1 Introduction and background

Transport for New South Wales (TfNSW; formerly Roads and Maritime Services) proposes to build the M12 Motorway between the M7 Motorway at Cecil Hills and The Northern Road at Luddenham (the project), over a distance of about 16 kilometres.

1.3 Overview of proposed changes

Figure 2-1 Key features of the amended project

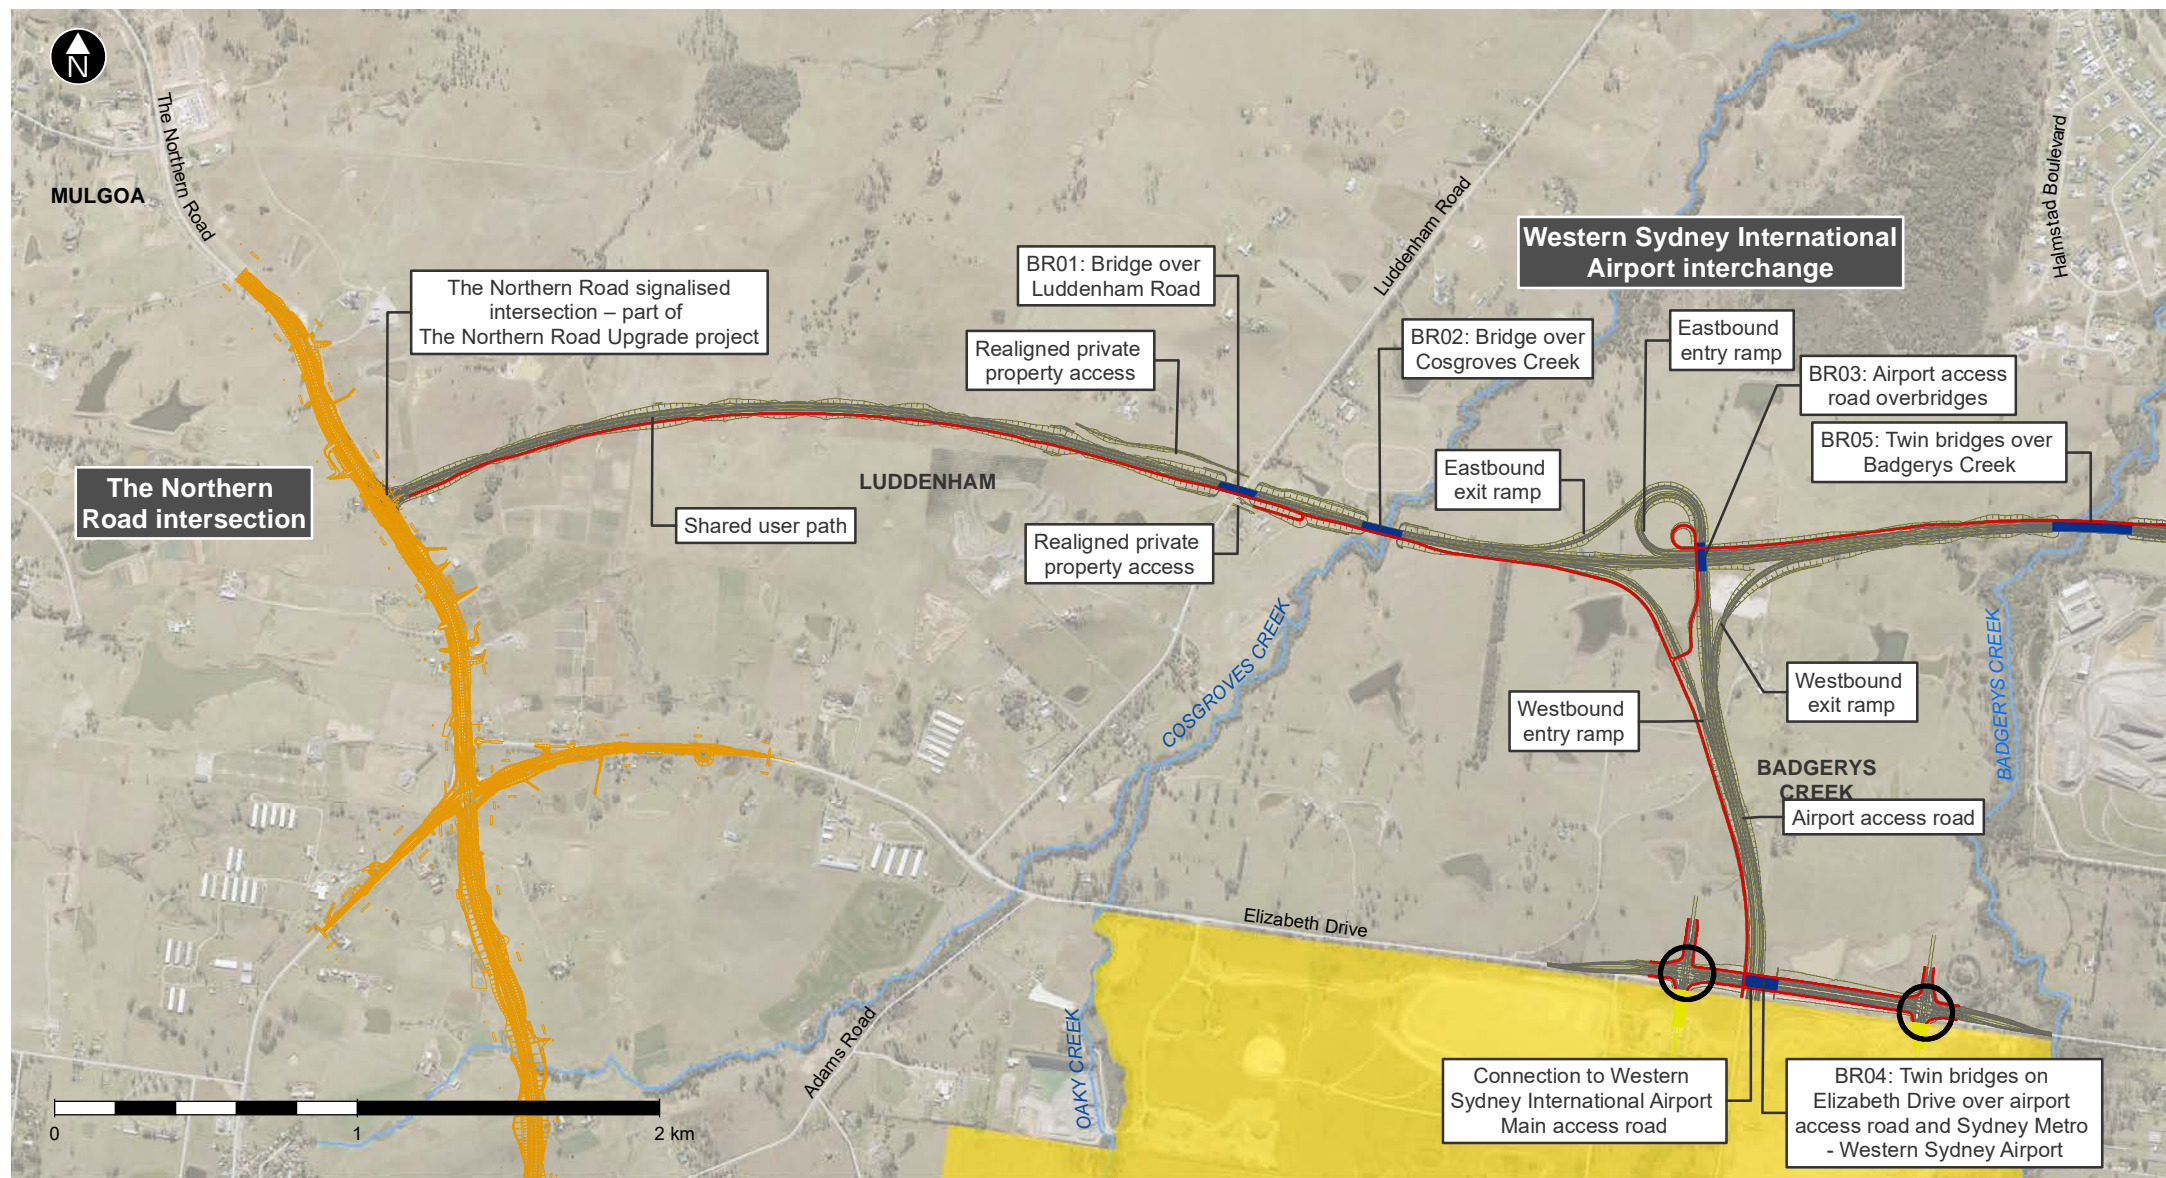
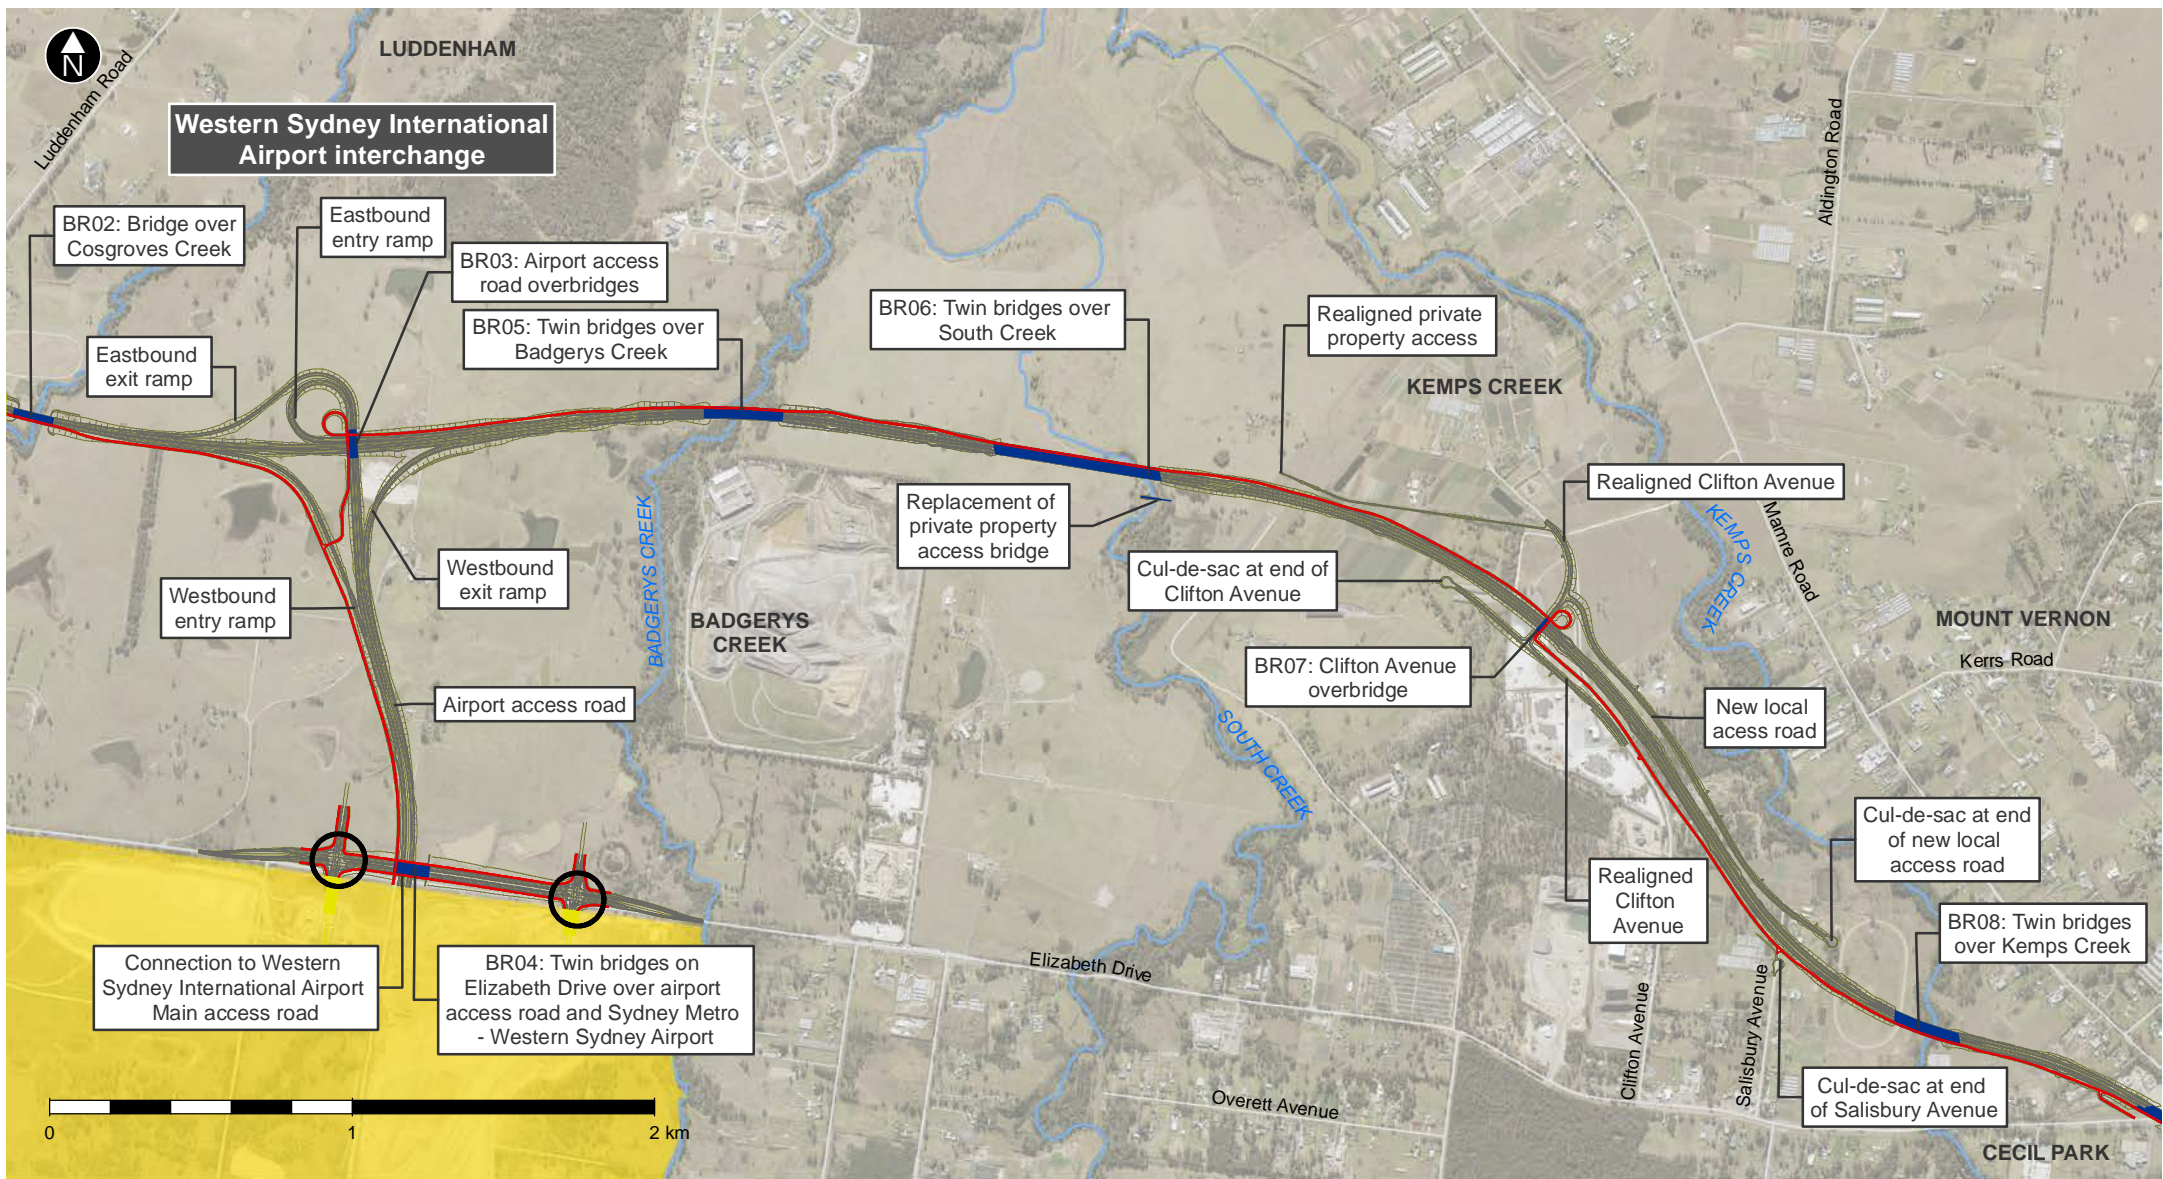
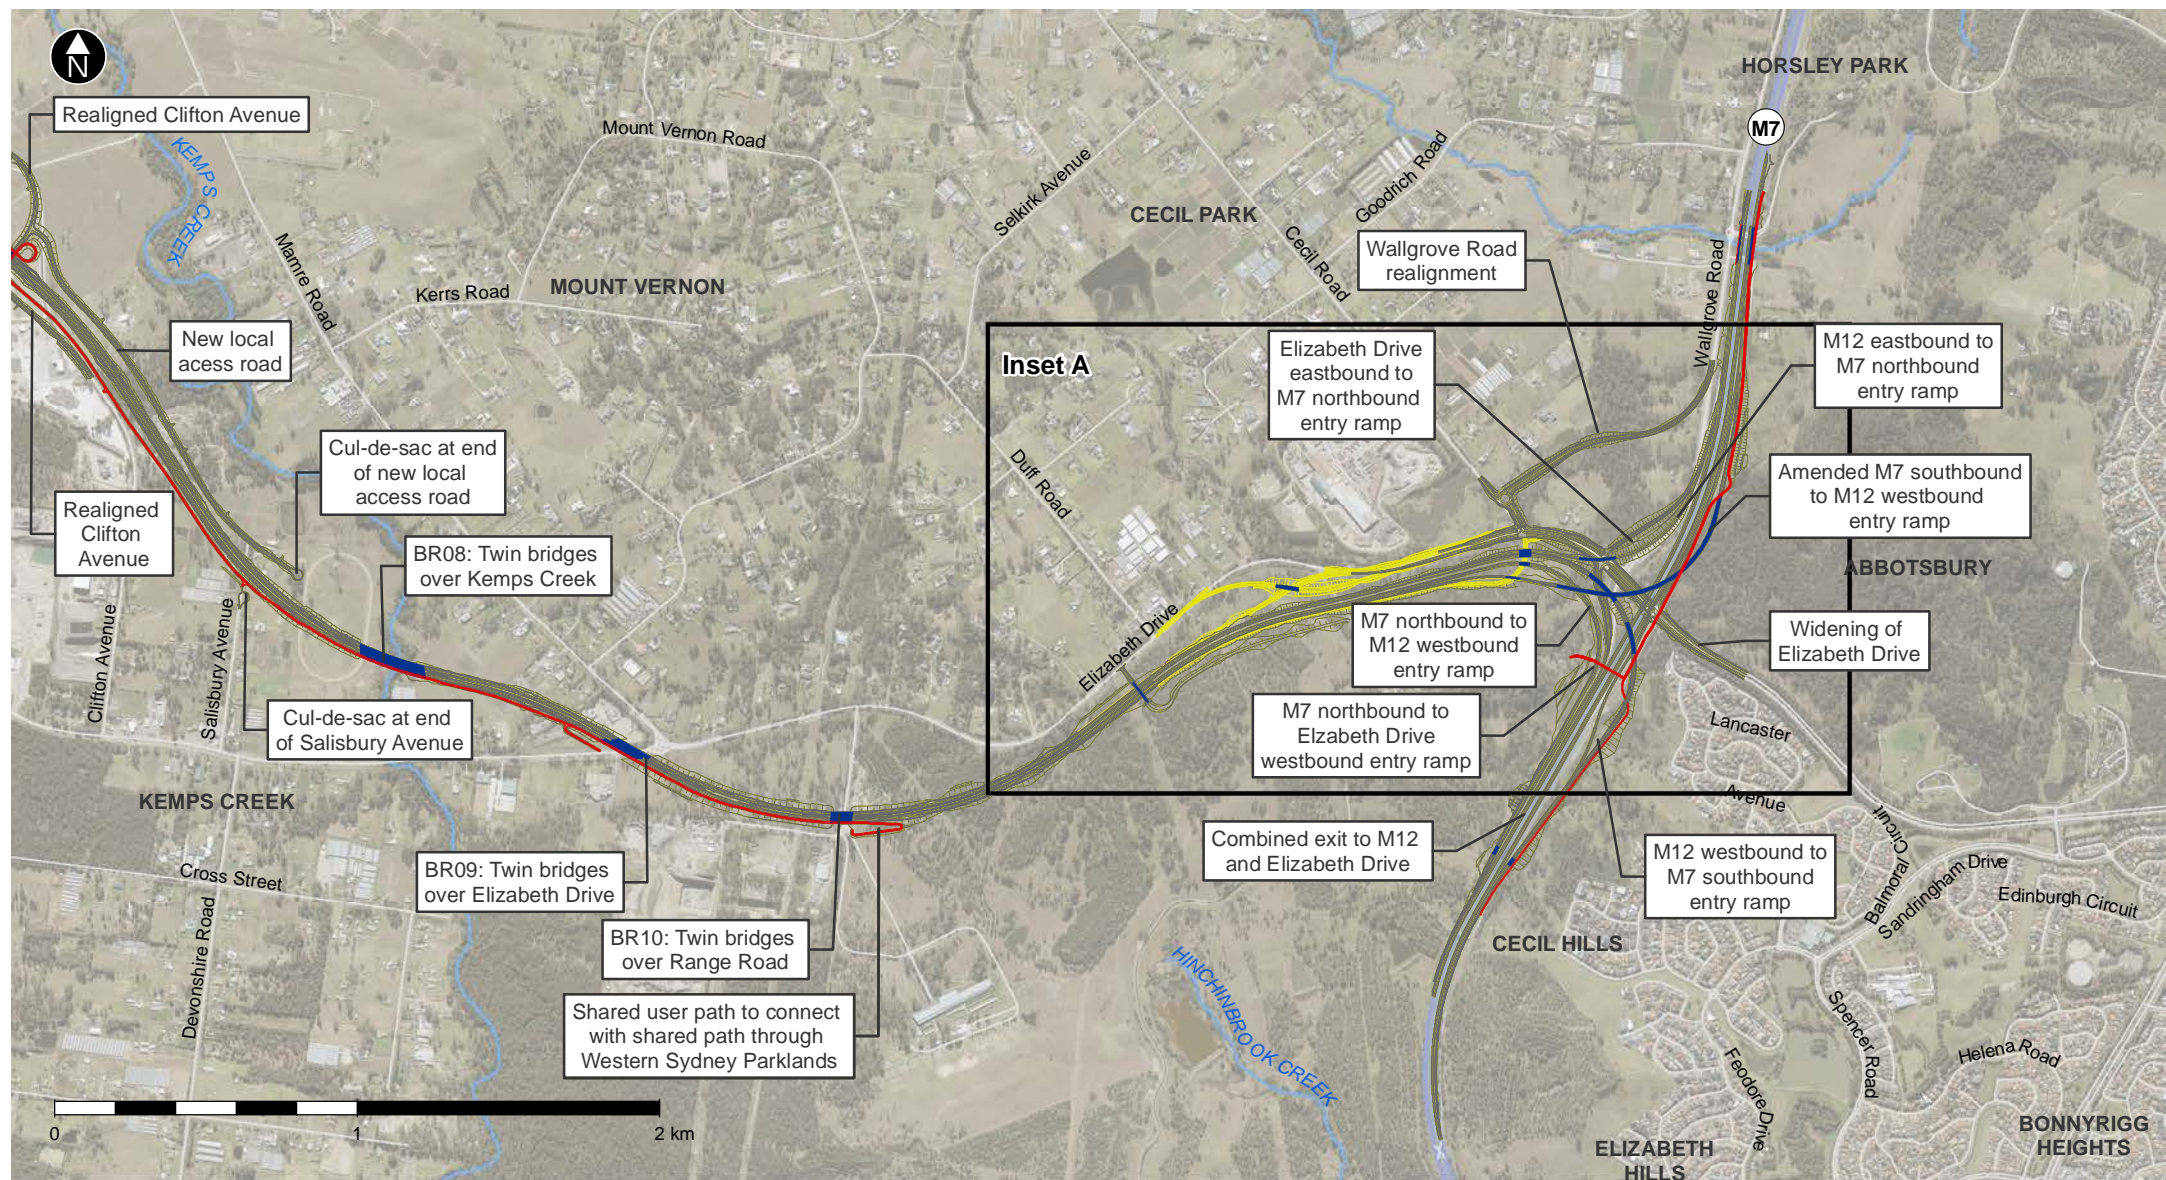
The key features of the amended project are listed below. Where the description of the proposed amended project key features differs from the description listed in the EIS, those changes are shown in **bold** text:

- **Two new signalised intersections from Elizabeth Drive into the Western Sydney International Airport, with provisions for future connection to potential developments to the north**

- **Widening of Elizabeth Drive under the M7 Motorway and approaches**
 - Realignment of Clifton Avenue over the M12 Motorway, with associated adjustments to nearby property access

- Relocation of Salisbury Avenue cul-de-sac, on the southern side of the M12 Motorway
 - **Realignment of Wallgrove Road to connect to Cecil Road, including a connection between Elizabeth Drive and Wallgrove Road via Cecil Road with a signalised intersection with Elizabeth Drive**
